SUBJECT: ISSUANCE OF AMENDMENT NO. 55 TO FACILITY OPERATING LICENSE NO. DPR-18, R. E. GINNA NUCLEAR POWER PLANT (TAC NO. M82497)

Amendment No. 55
License No. DPR-18

SAFETY EVALUATION BY THE OFFICE OF NUCLEAR REACTOR REGULATION
RELATED TO AMENDMENT NO. 55 TO FACILITY OPERATING LICENSE NO. DPR-18
ROCHESTER GAS AND ELECTRIC CORPORATION
R. E. GINNA NUCLEAR POWER PLANT
DOCKET NO. 50-244

FIGURE 5.1-1

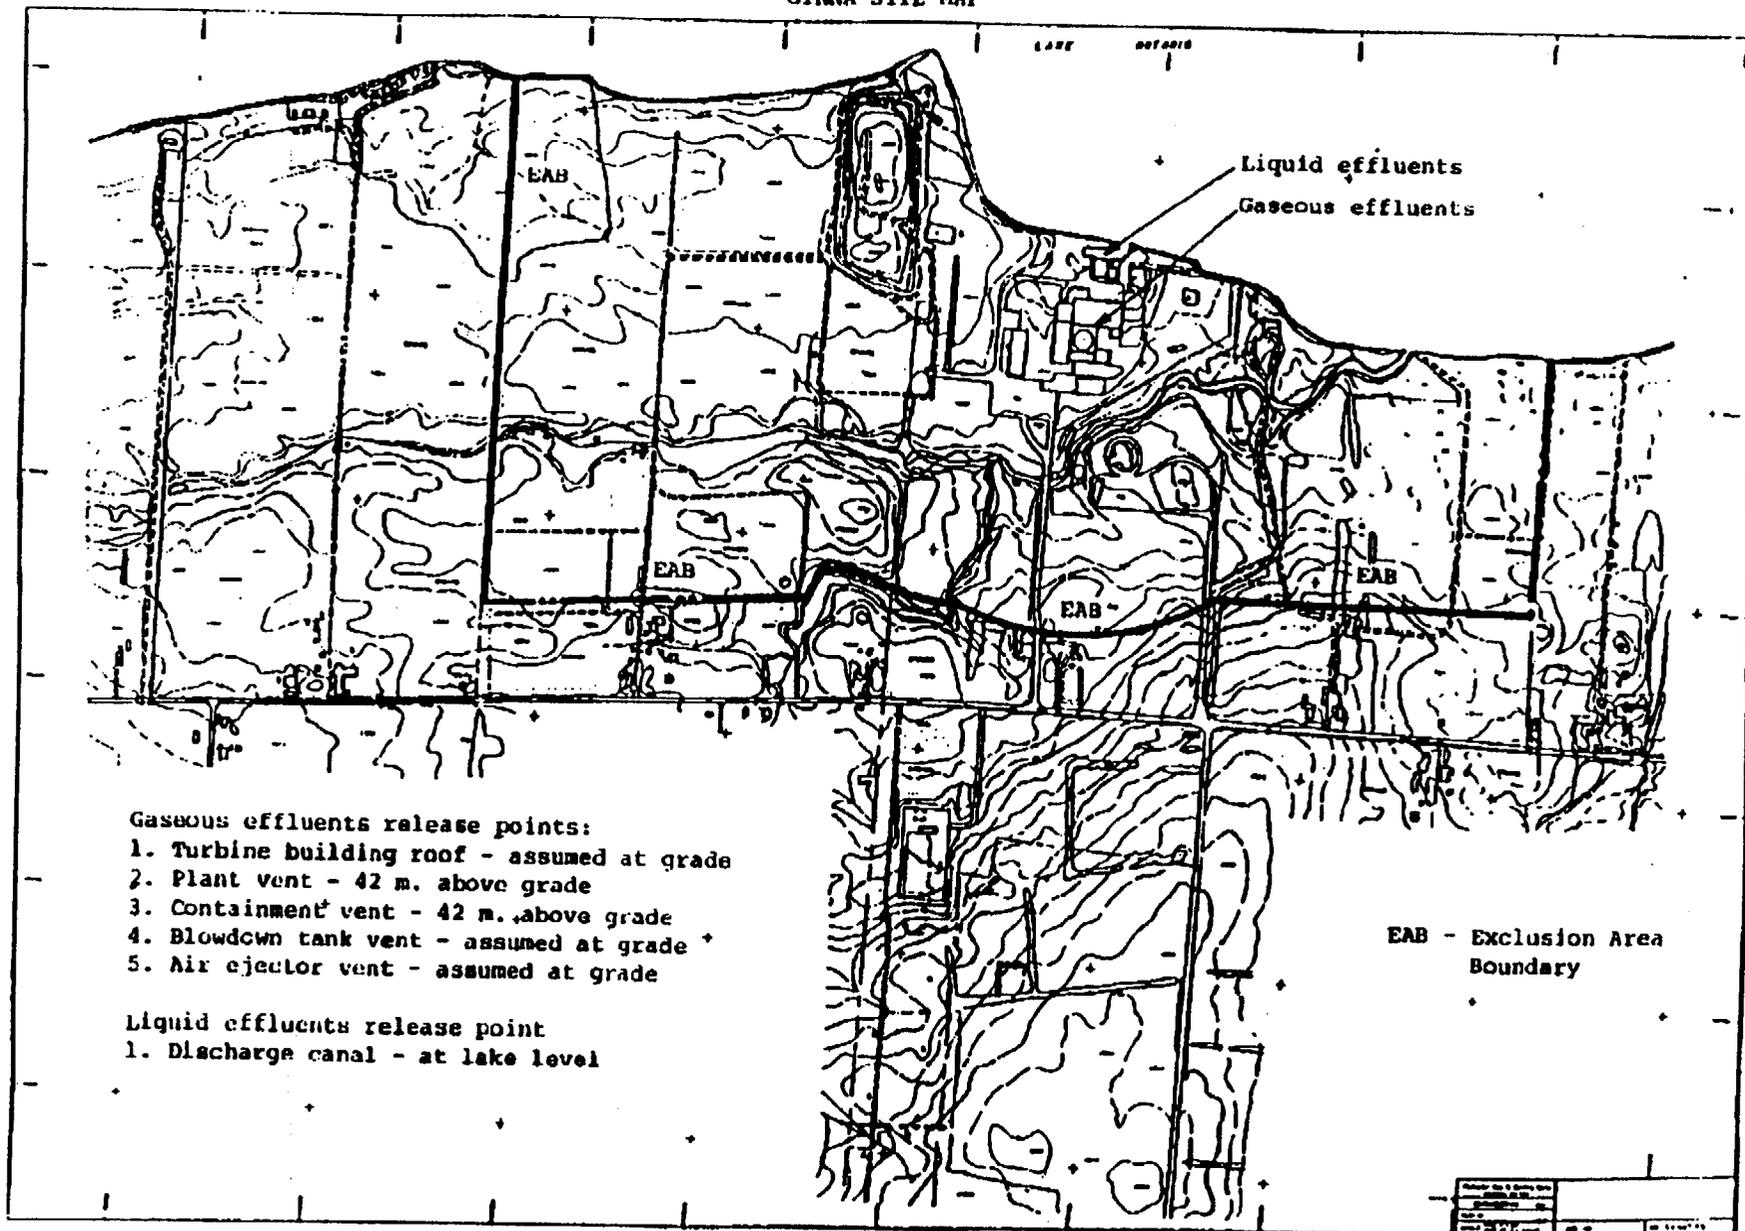
The amendment revises Technical Specifications (TS) 5.1 and Figure 5.1-1 to define, rather than depict, the site boundary. The staff's review finds that the proposed change is administrative in nature.

Further, in the proposed TS Figure 5.1-1, the indication of site boundary has been erased, but the figure depicts the location of Ginna Exclusion Area Boundary as unchanged. And TS 5.1.1 clearly described that:

5.1.1 For the purposes of implementing Ginna Radiological Technical Specifications, and for evaluating radiological releases to the Unrestricted Area, the Unrestricted Area Boundary is assumed to coincide with the Exclusion Area Boundary. The site map shown in Figure 5.1-1 depicts the Ginna Exclusion Area Boundary (also called Unrestricted Area Boundary) location.

5.1.2 The site boundary shall be that line beyond which the land is neither owned, nor leased, nor otherwise controlled by Rochester Gas & Electric Corporation.
